From: Robyn Seymour <rseymour@chorus.net>
Sent: Tuesday, November 19, 2019 8:59 AM
To: DiMaggio, Janet H - DNR
Subject: RE: Rath PECFA request
Attachments: Figure 1-mod.pdf; WSlog-Donar.pdf; WSlog-Hamilton.pdf; WSlog-Holt.pdf; WSlog-Hornbeck.pdf; WSlog-Hornbeck2.pdf; WSlog-Jenamann.pdf; WSlog-Keck.pdf; WSlog-Lux.pdf; WSlog-LuxFarm.pdf; WSlog-Mitchell.pdf; WSlog-Popp.pdf; WSlog-Sweet.pdf; WSlog-Timmerman.pdf

From: DiMaggio, Janet H - DNR <Janet.DiMaggio@wisconsin.gov>
Sent: Friday, November 15, 2019 4:37 PM
To: Robyn Seymour (rseymour@chorus.net) <rseymour@chorus.net>
Subject: Rath PECFA request

**PROPOSED MONITORING WELL LOCATIONS
RATH PROPERTY
1304 Saint Rose Road
Cuba City, Wisconsin**

**FIGURE
1**

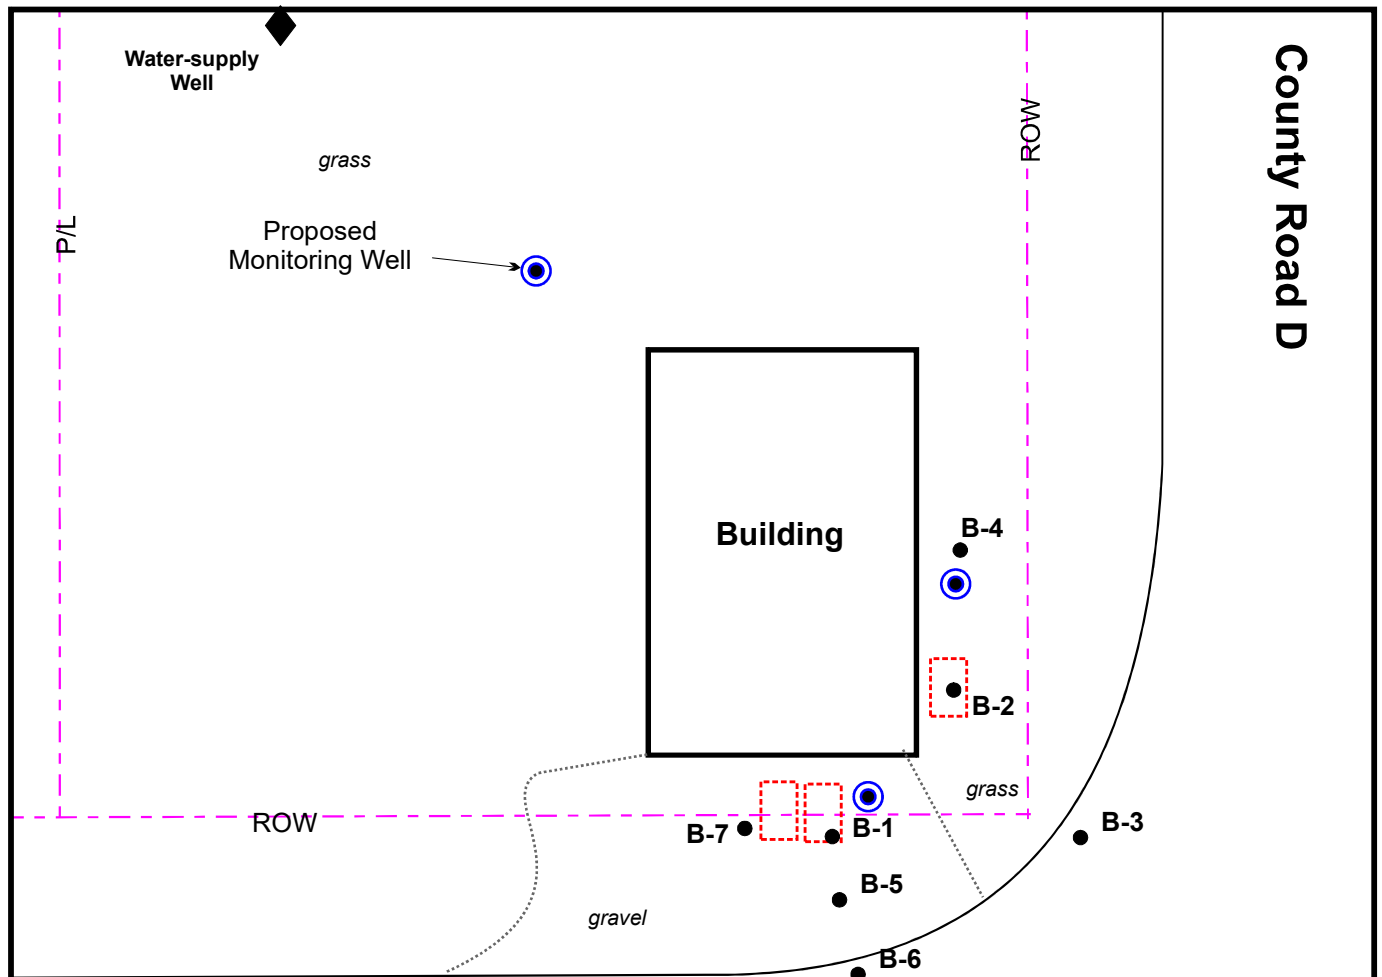
In the attachment to your July 2019 email, the supply well was located closer to the building than in the November 2019 cost request.

- Please verify where the water supply well is located. **The recent map (November) is correct, I took measurements while I was out there recently. The first map was done using an aerial photo.**
- Do you have any information on the well construction of the supply well? **I have attached a few well forms but we are not sure if any of these are for the subject site. We will be installing wells into first water.**

I am verifying the wells are proposed to be installed post excavation. The letter says the excavation occurred but the map lists it as proposed. **The excavation has been conducted but we used an old map, I took the excavation of for now.**

Since there is no proposed soil sampling of the boring for the proposed well between B-2 and B-4, can you tell me if the confirmation sidewall samples showed any residual petroleum soil contamination in that area? **There is no contamination at this location, the excavation sidewall at this location was clean and B-4 had no detects.**
